1394 Link Layer Controller chip (TSB12C01A) Errata:

Last Changed on 07/06/96 - bsh, rgg

TSB12C01A Data Book Errata:

Figure 4-10. Receive Self-ID Format

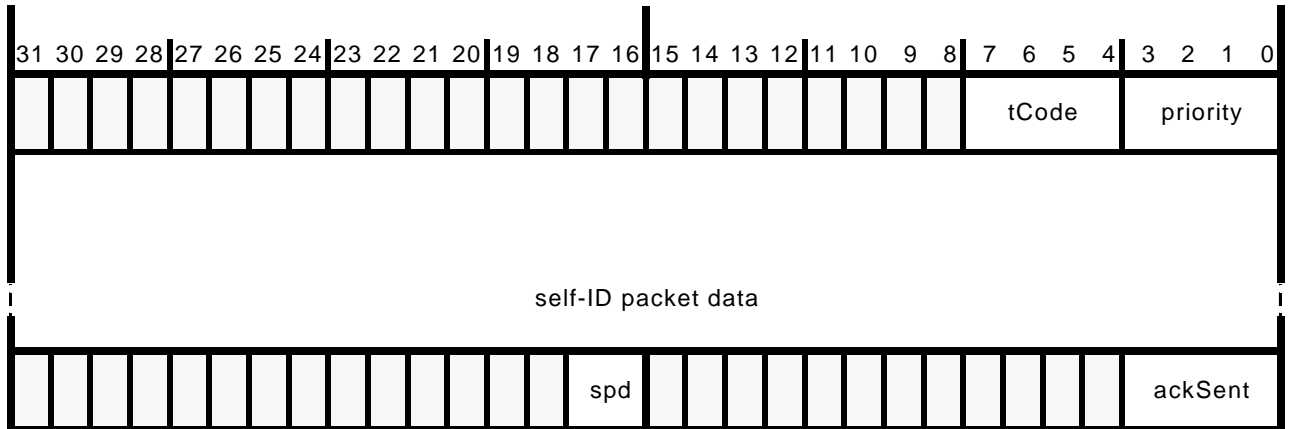
1. Page 4-8 (Section 4.7 Receive Self-ID) should be replaced with the following page.

The format of the receive self-ID packet is shown in Figure 4-10. The first quadlet is the packet header with the special tCode of Eh. The quadlets following are a concatenation of all the received self-ID packets, followed by the final packet status quadlet.

Field Name	Description
tCode	Special transaction code of 1110b
priority	The priority level for this packet.
Self-ID packet data	The concatenation of all self-ID packets recieved.
spd	This field indicates the speed at which this packet was sent. All self-id packets are sent at the base rate of 100Mbps. spd = 00 for 100 Mbps
ackSent	This field holds the acknowledge sent by the receiver for this packet.
